UNIVERSITY OF
MARYLAND

Radiation Facilities

**DRAFT EDIT IN RESPONSE TO USNRC QUESTIONS IN REGARD TO MUTR RELICENSING
DATED January 25, 2005**

**TECHNICAL SPECIFICATIONS
FOR THE
MARYLAND UNIVERSITY TRAINING REACTOR**

Figure 6.1: MUTR Position In University Of Maryland Structure

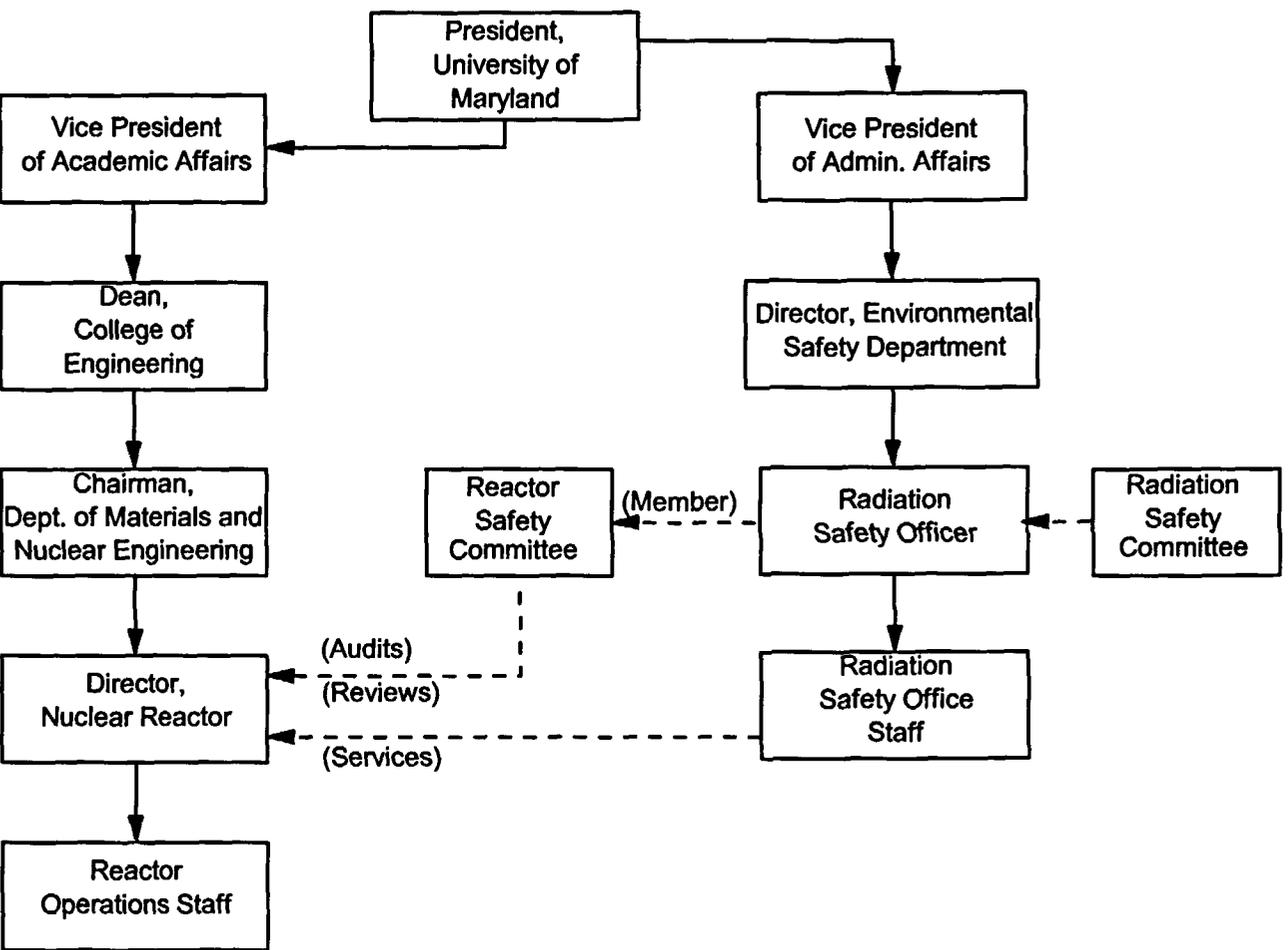
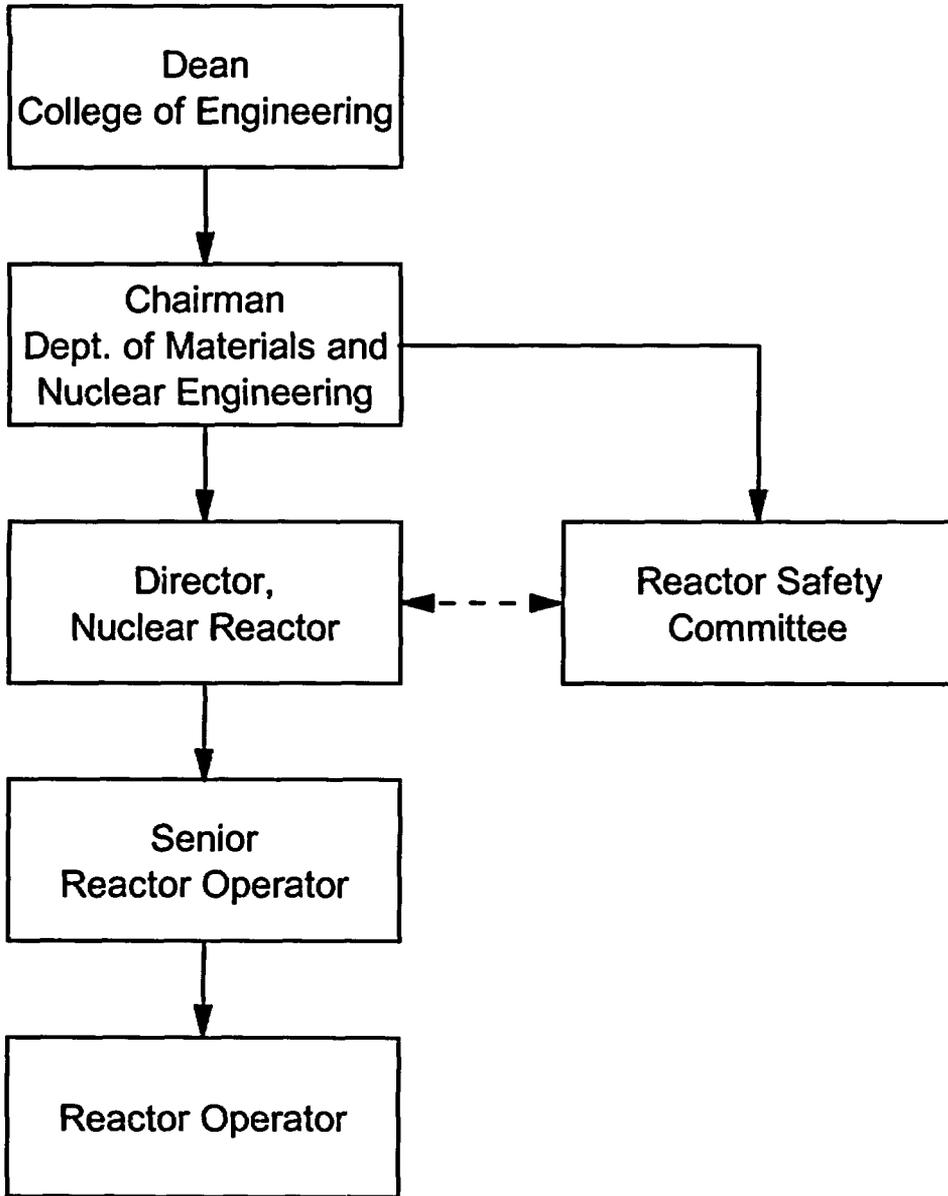
103. TS Figure 6.1 and 6.2. Please clarify the meaning of solid and dotted lines on the structure diagrams. The solid line shown on Figure 6.2 between the Chairman of the Department of Materials and Nuclear Engineering and the Reactor Safety Committee is not on Figure 6.1 (similar comments on SAR Figures 12.1 and 12.2). Please explain.

ATTACHMENT 1: RESPONSE TO QUESTION 84

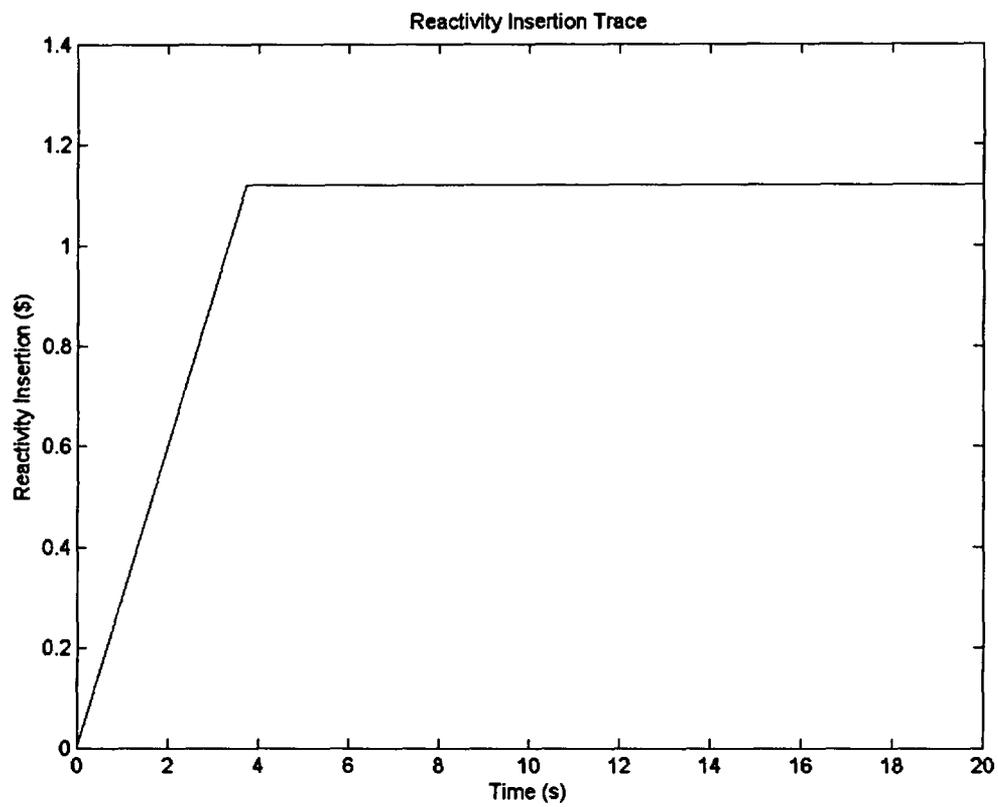
84. TS 3.2.2, REACTOR CONTROL AND SAFETY SYSTEMS. Please discuss the maximum power ramp that would result from adding \$0.30 per second of reactivity to the reactor, starting from a low power condition. Also, discuss the reactor safety system response to the reactivity addition, including power overshoot.

Four scenarios for \$0.30/s insertion will be considered for reactor response with absolutely no human intervention:

The second scenario considered is with a low initial power and with an inoperative period safety system, so that any power fluctuations with a period shorter than 5s are not scrammed. Prompt fuel temperature increases as a result of a sharp increase of power would add controllability, and would lessen the increase in power. Assuming an initial power of 1mW, a \$0.30/s reactivity insertion would finish inserting reactivity after 3.7 seconds (Appendix A), giving the reactor a minimum period of 0.00562s at 2.23s (Appendix B). At this point, the prompt temperature increases have effectively started to remove excess reactivity at a rate of \$0.30/s. The power would continue to rise, which would continue to raise the fuel temperature, until the fuel temperature took away all of the excess reactivity. Eventually, the reactor power would level off. However, there are two independent safety systems, Safety 1 and Safety 2, which would scram the reactor before it got to 120% of full power (300kW). The power would reach 300kW at approximately 14.5s (Appendix C). Assuming the maximum allowed 1s lapse in time from the scram signal occurs before the Control Rods are inserted, and assuming the full negative reactivity of the Control Rods is inserted instantly, the power would rise to maximum of 303.15kW before dropping down to 153.6kW in a prompt drop and then exponentially decaying with a negative 80s period.

The first and second scenarios were considered with an initial power of 1mW. Simulations were done for several initial powers. According to the results, regardless of the initial power, as long as it is below the point of adding heat, the powers will converge to a power trace that levels off and then slowly increases as the moderator is heated up, adding excess reactivity (Appendix D).

The third scenario considered is with a high initial power, and with either of the Safety 1 or Safety 2 safety systems in working order, scrambling any power that is greater that or equal to 120% of full power (300kW). This is also a realistic scenario, as both independent systems are robust and have been consistent in their operation. As the initial power increases, the initial fuel temperature also increases, which lowers the excess reactivity. Therefore, this scenario is more realistic than the second, as there is insufficient reactivity to obtain a period shorter than 5s. The period scram setpoint does not come into play in this scenario. The power simply

converges to the low initial power trace, and then scrams at 120% of full power. The scram time will change depending on what the initial power is.
